NOVATO SANITARY DISTRICT

**ADDENDUM NO. 1**

**FORCE MAIN CONDITION ASSESSMENT**

**(Project No. 72403-2023-01)**

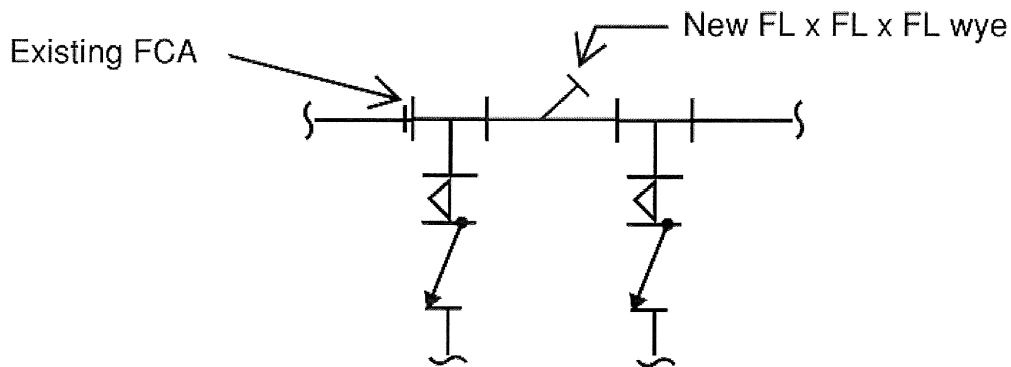
19. For the Scottsdale FM, are there drawings of the modifications expected in the launch vault available?

**Response:** See the following diagram. NSD will install the wye shown in advance of inspection. Note that the wye will be oriented vertically and will not be in the same plane as the other piping.

Attachment 3. Alternate Scottsdale Discharge Manhole Access Figure

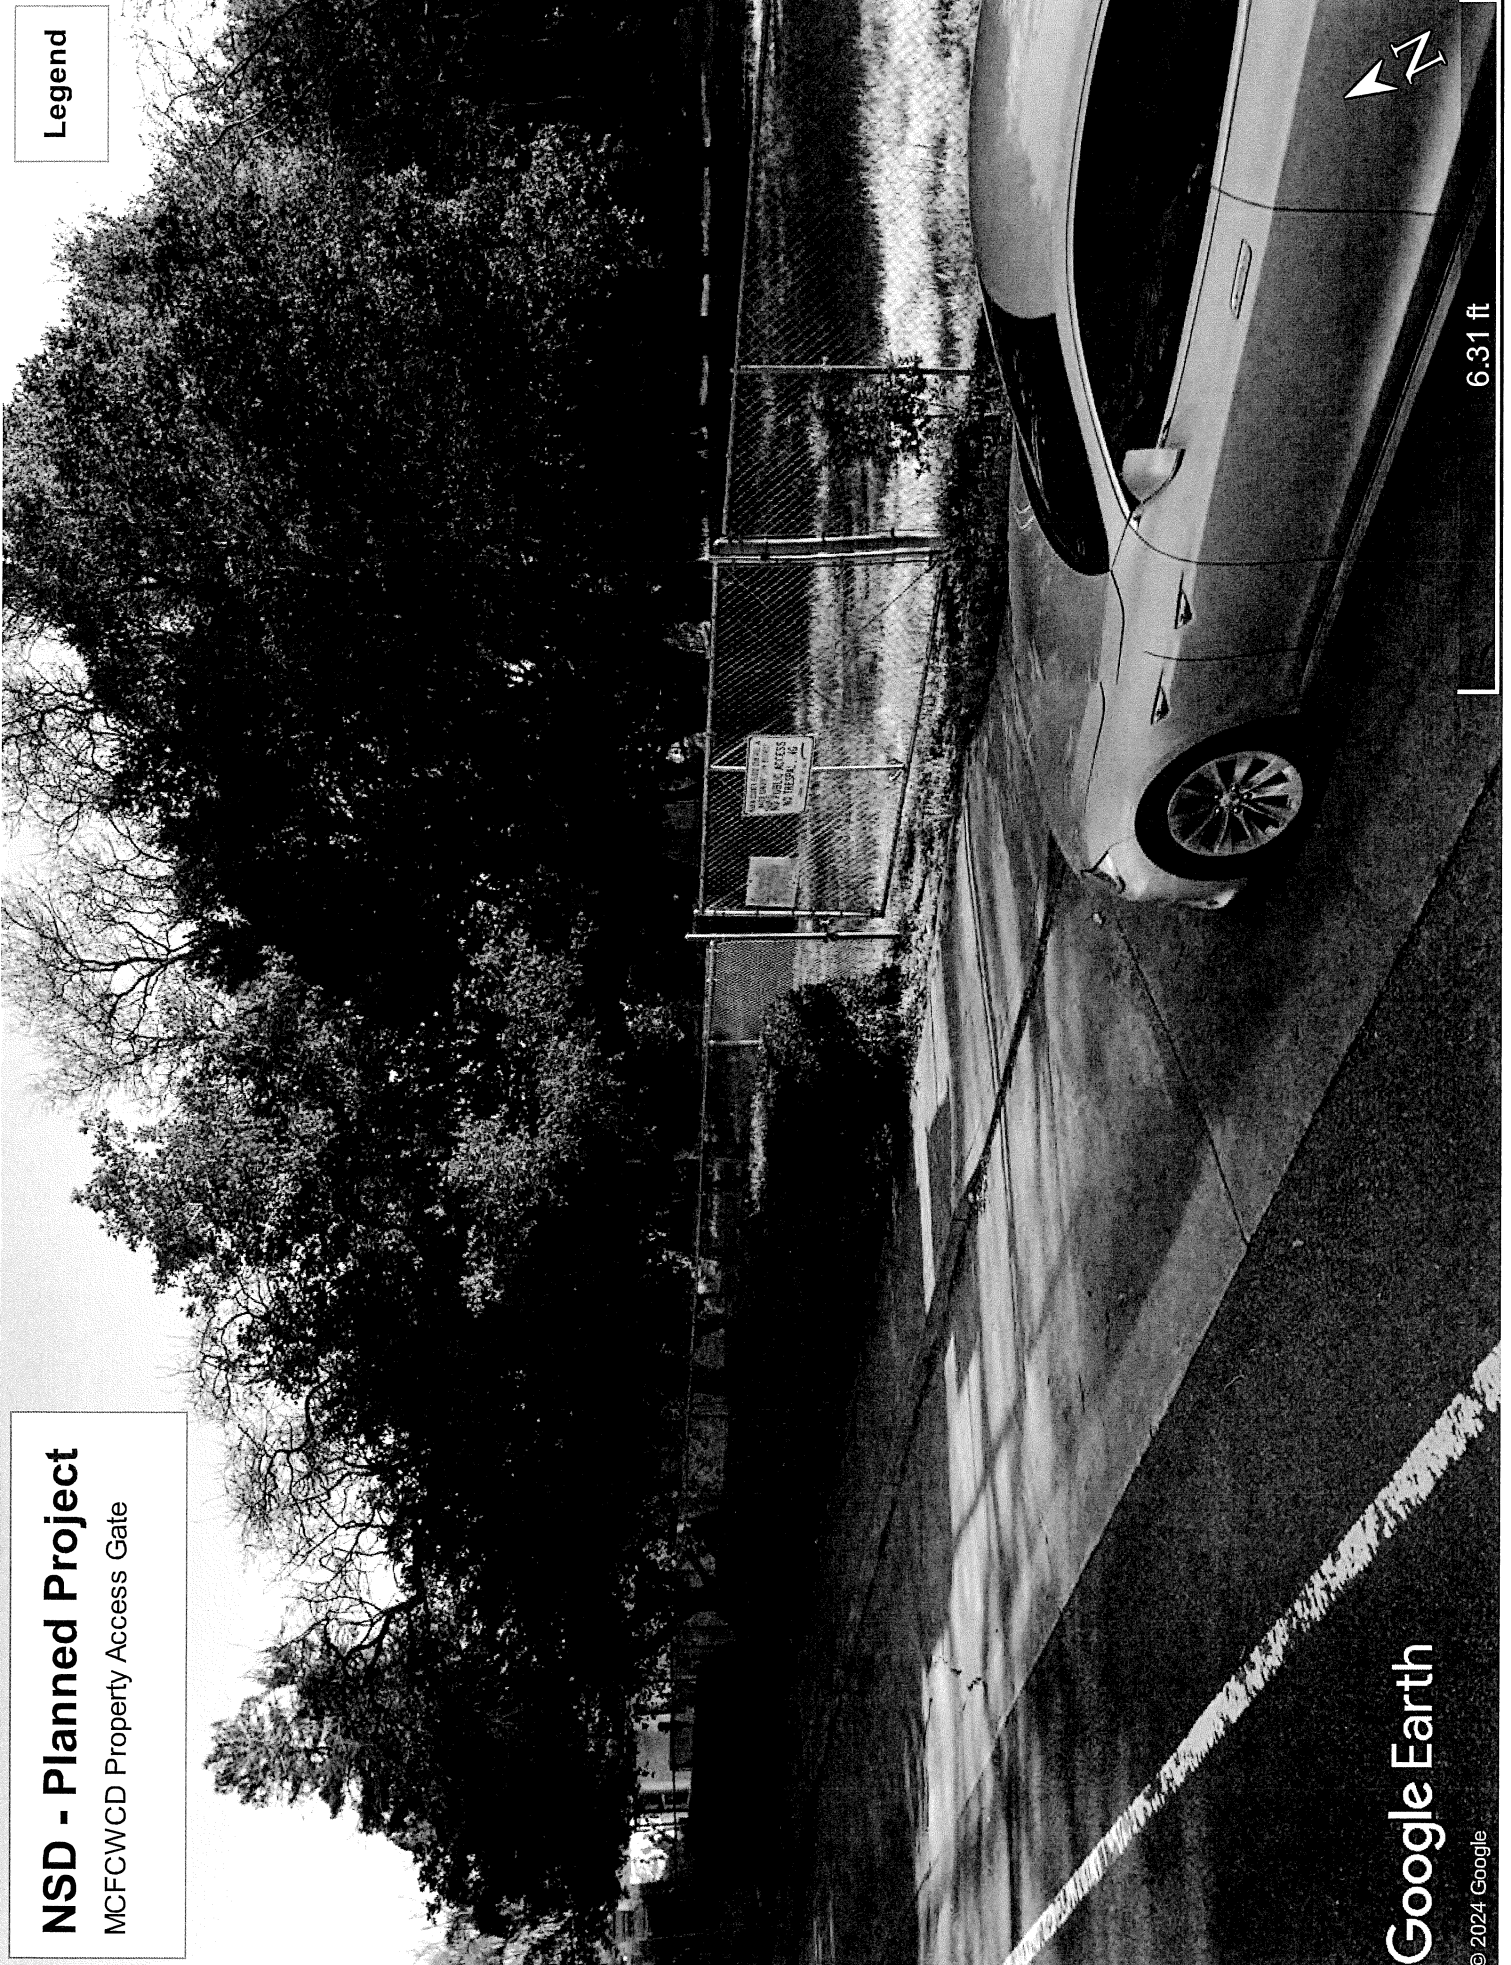
1. An updated cost proposal form is included as Attachment 1. It reflects changes made in response to bidder questions and contains fields for bidder acknowledgement of receipt of addenda.
2. An alternate means of accessing the discharge manhole of the Scottsdale Force Main is shown in Attachment 3. This access method is easier than the method included in the supporting files of the RFP.
3. A map showing the point of isolation closest to the Scottsdale Pump Station along the Scottsdale Force Main is included as Attachment 4. This isolation will be provided by a gate valve that NSD will install prior to inspection.
